Smith Drive/Louisville Drive Traffic Calming

I want to thank the City for this opportunity to comment on the planned Smith Drive/Louisville Drive traffic calming project.

SMITH DRIVE/LOUISVILLE DRIVE TRAFFIC CALMING

Smith Drive Plan Sheet - Louisville Drive to Dayspring Drive

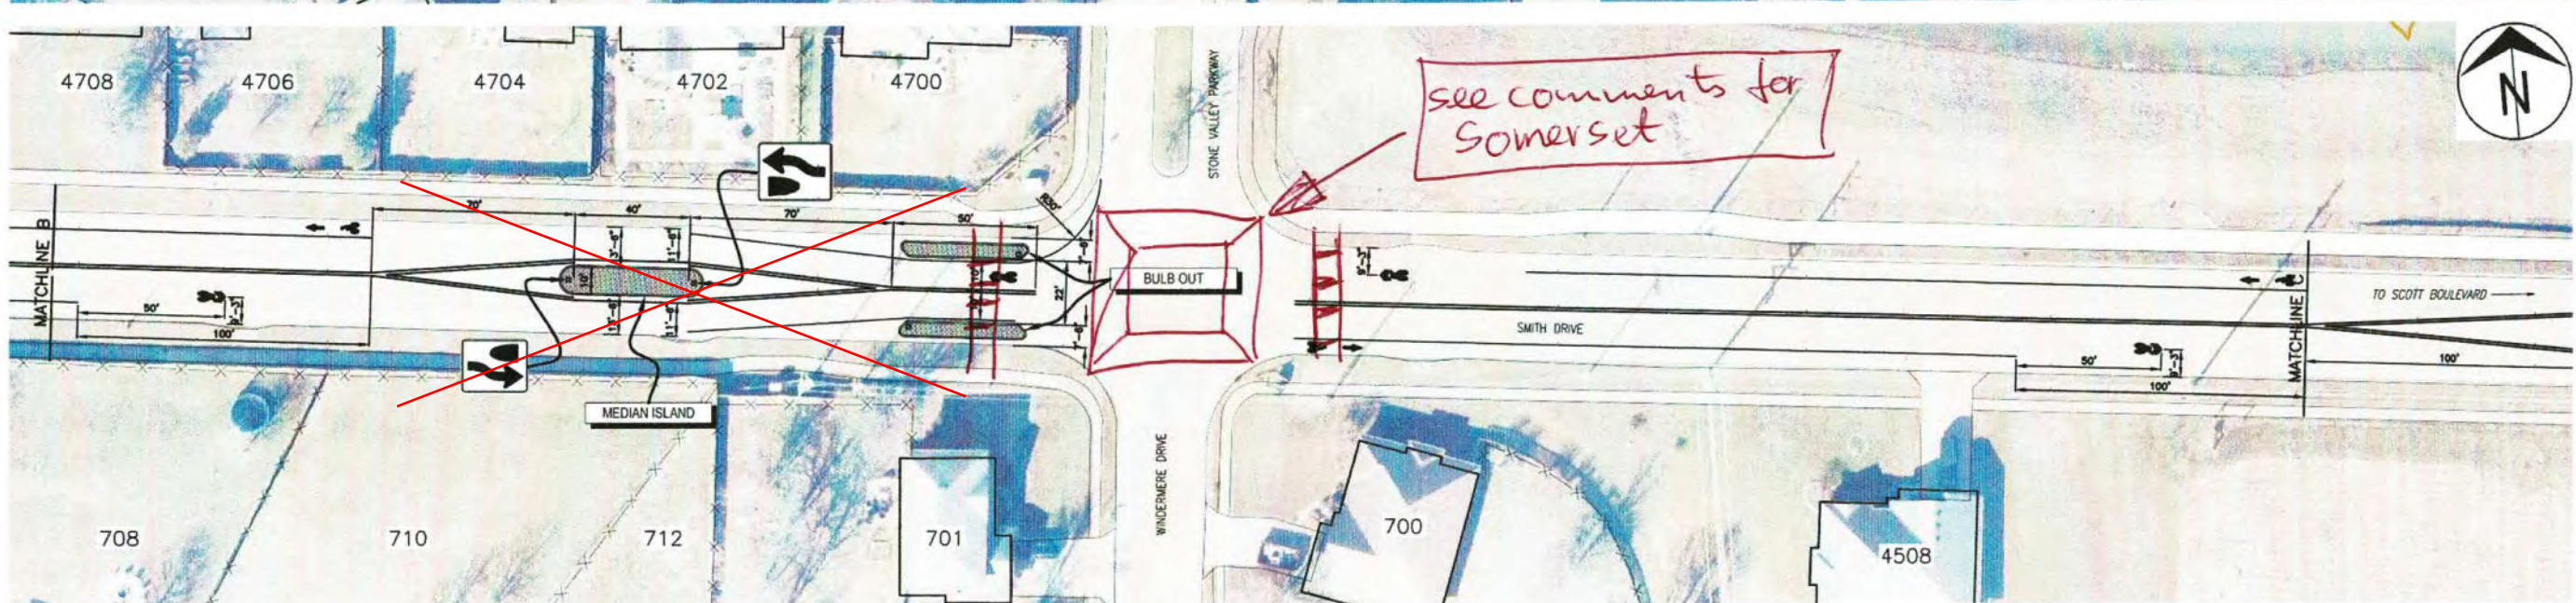
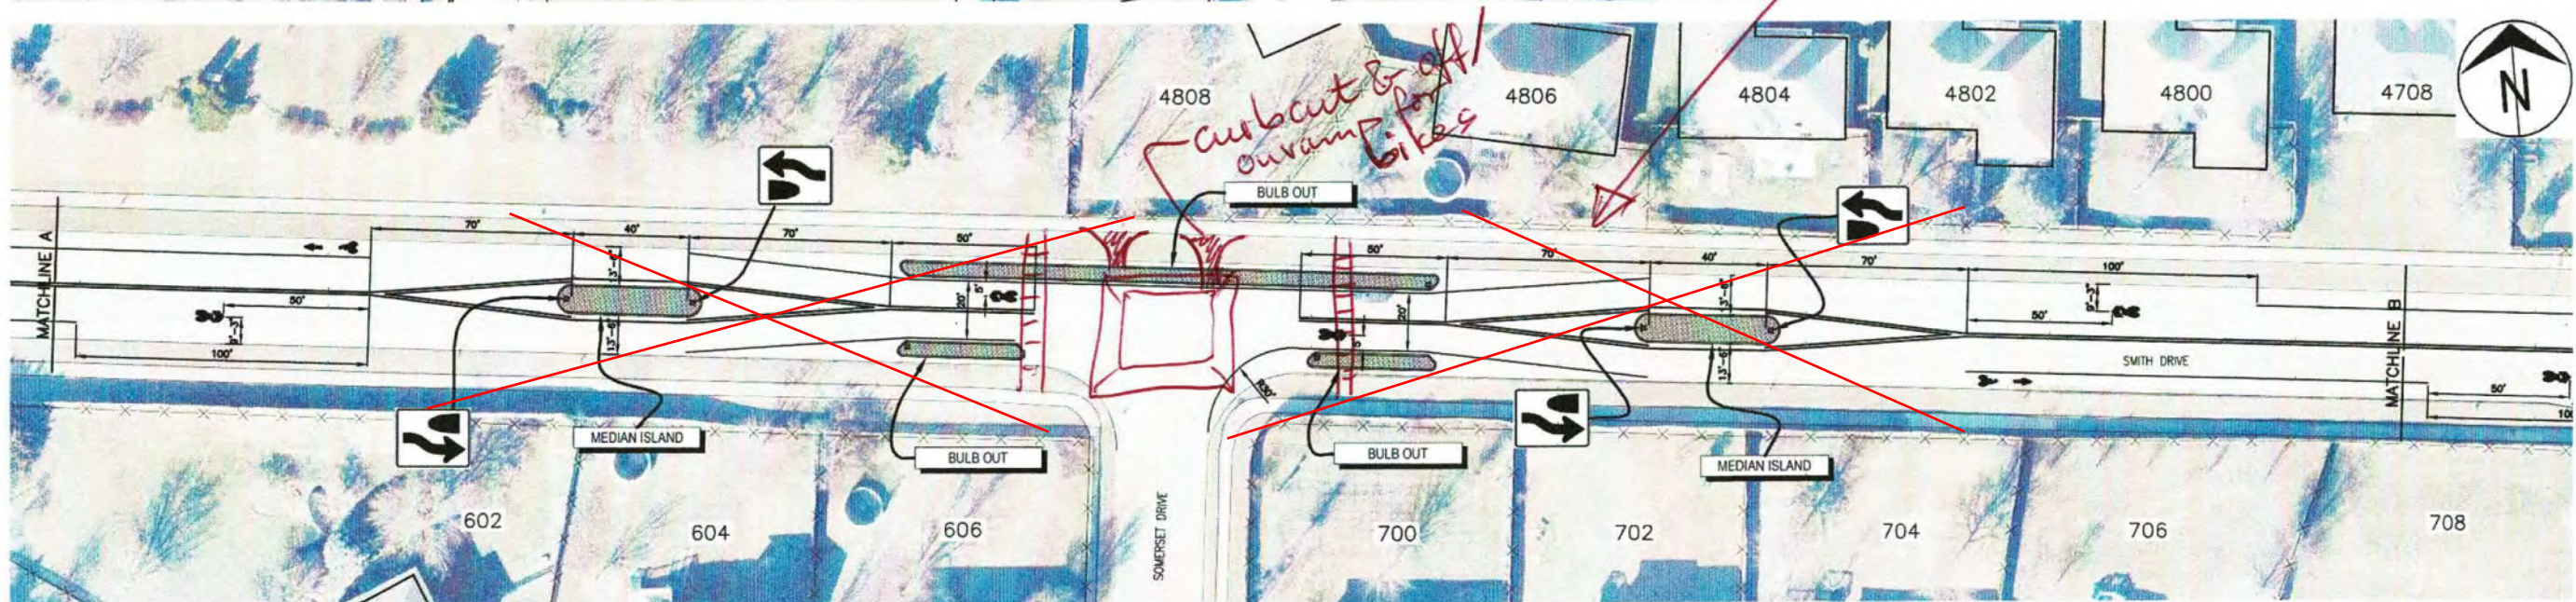
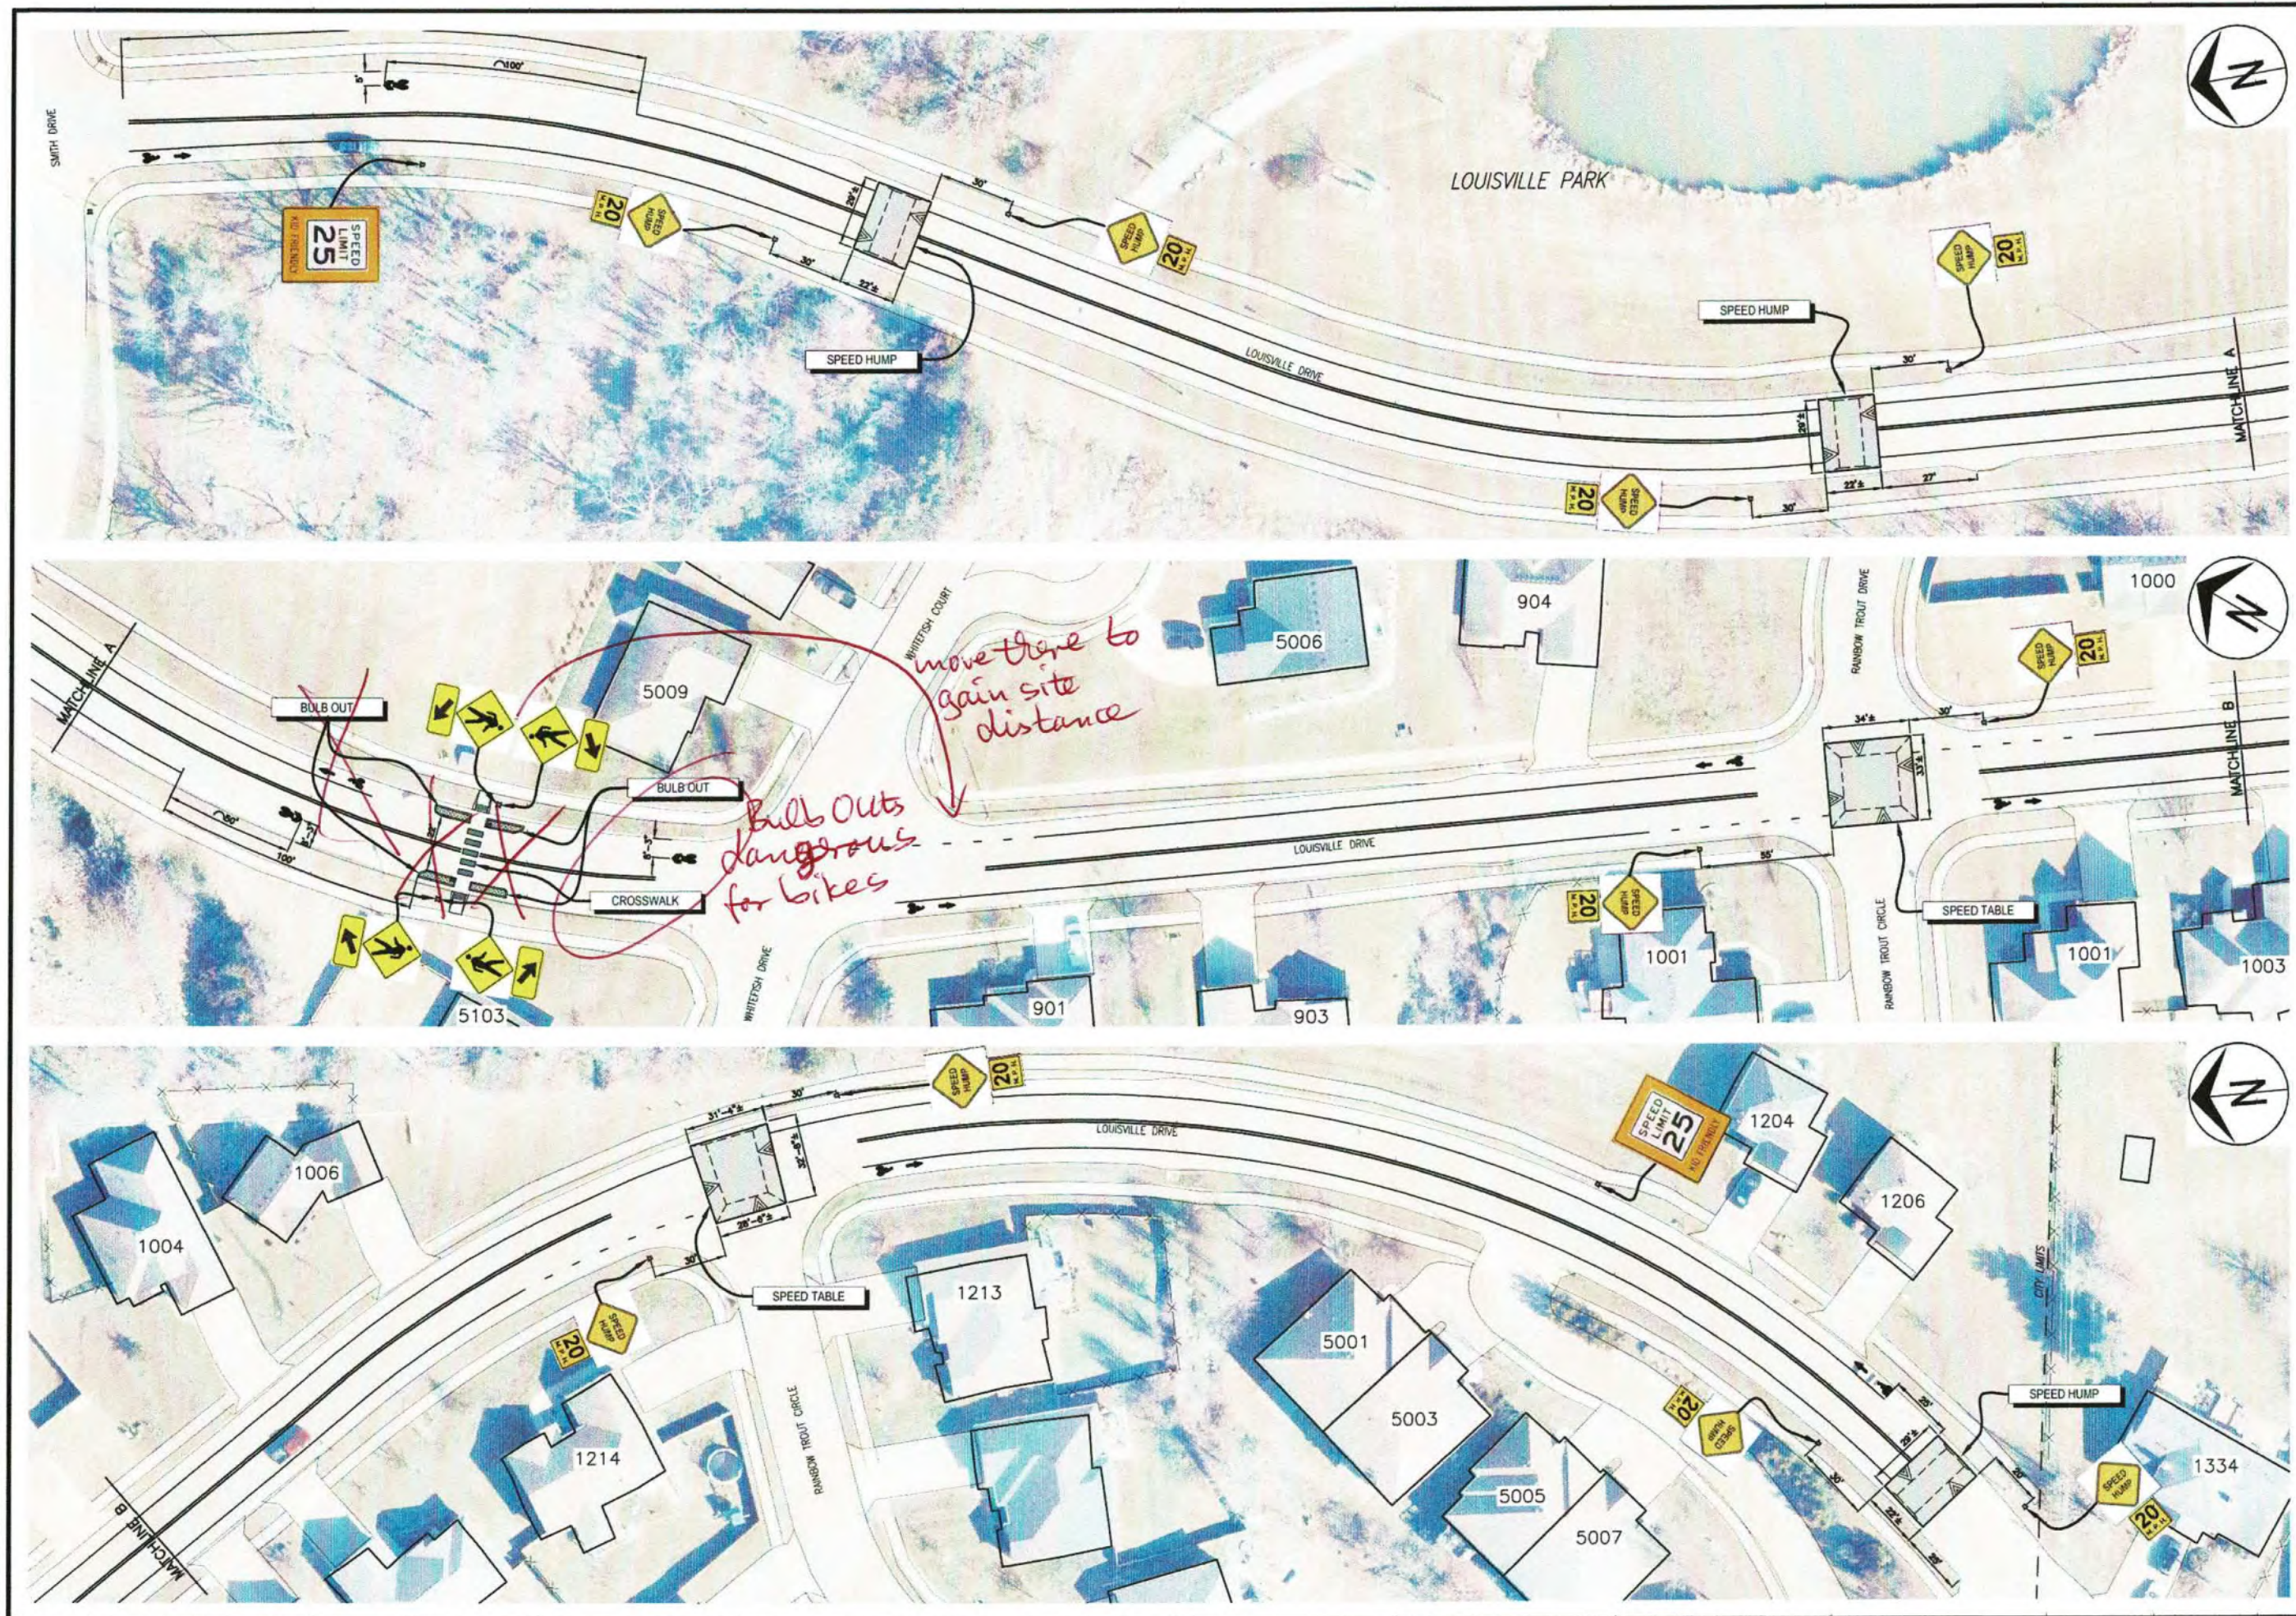
- This design forces bikes into the driving lane. 85% speed is >45mph → unsafe!
 - Makes snow removal difficult
 - Low visibility EB due to vertical curve
 → Add Xwalks on Smith Dr. & Speed Table
 Current design looks dangerous
 - Also provide "off" for bikes to/from Somerset to N Smith Dr. SW

LOUISVILLE DRIVE — RAINBOW TROUT DRIVE
1" = 20'

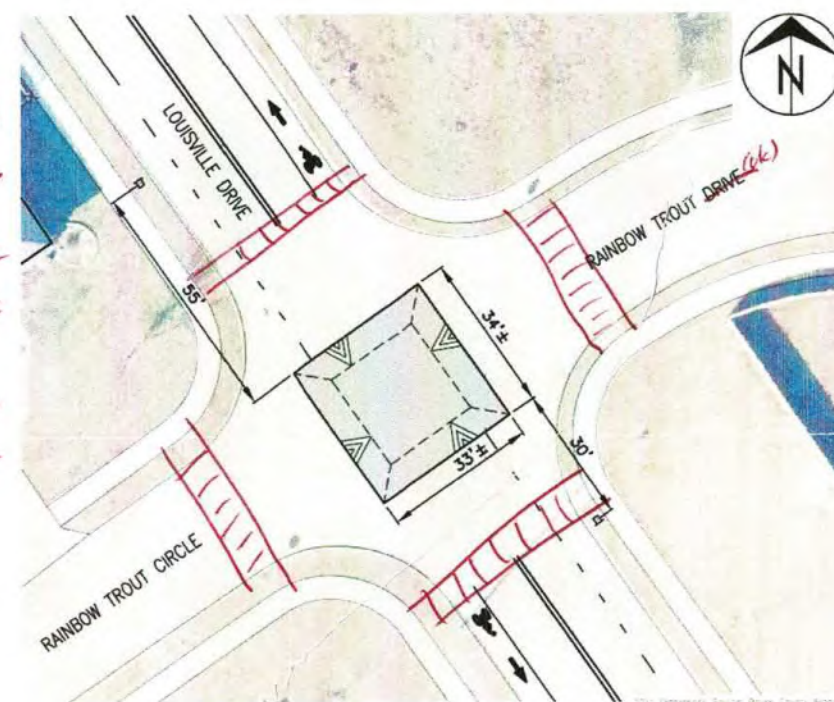
Add 4
Xwalks
Both Louisville
& Rainbow Trout
Dr. ave
cut-throughs
in dense neigh-
borhood

LOUISVILLE DRIVE — RAINBOW TROUT CIRCLE
1" = 20'

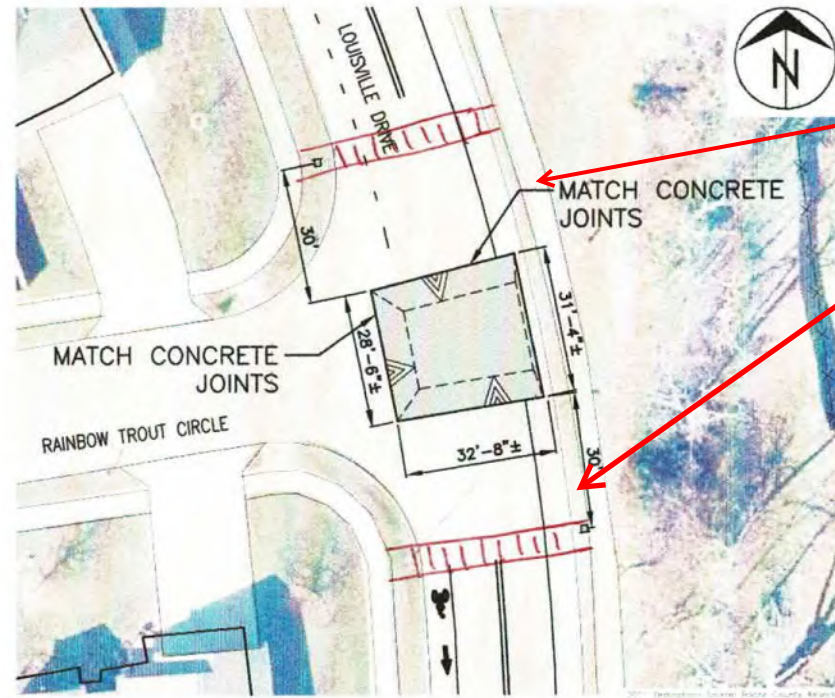
Visibility an issue due to horizontal curve → add Xwalks

LOUISVILLE DRIVE — LABRADOR DRIVE
1" = 20'

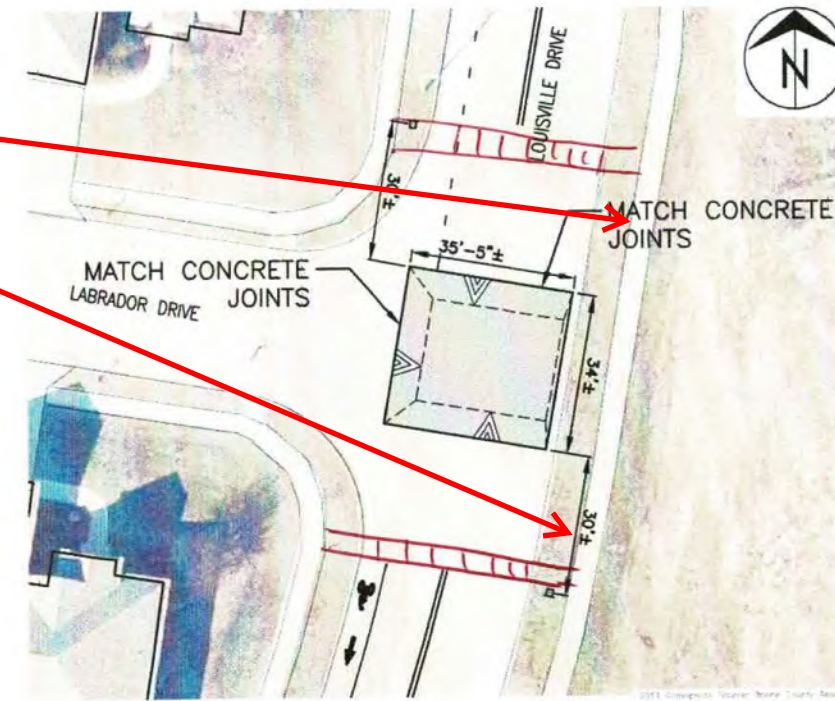
Add bike on/off ramps to SW. Not needed if Xwalks are constructed.

LOUISVILLE DRIVE — TIPTREE COURT
1" = 20'

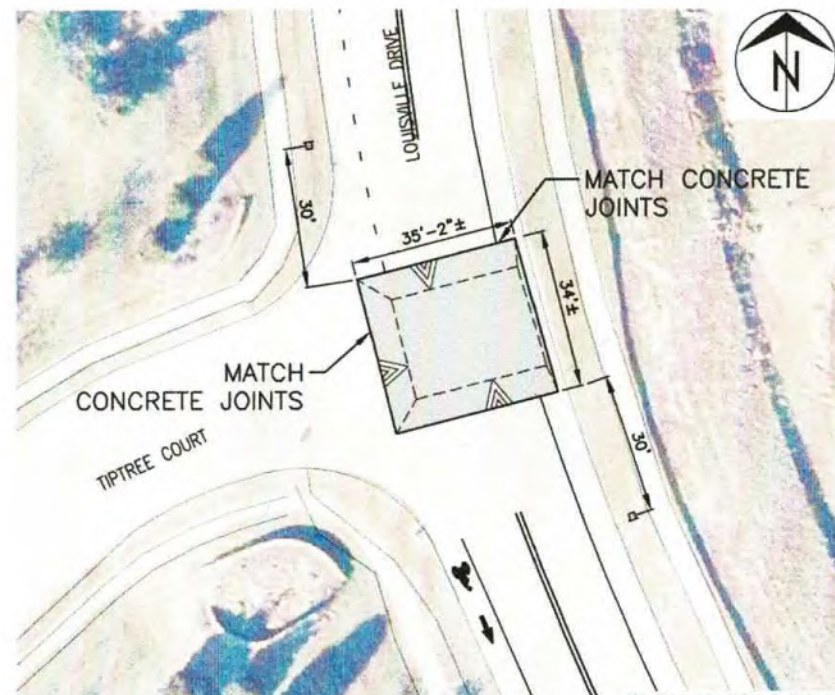
Low visibility due to vertical curve → add Xwalks
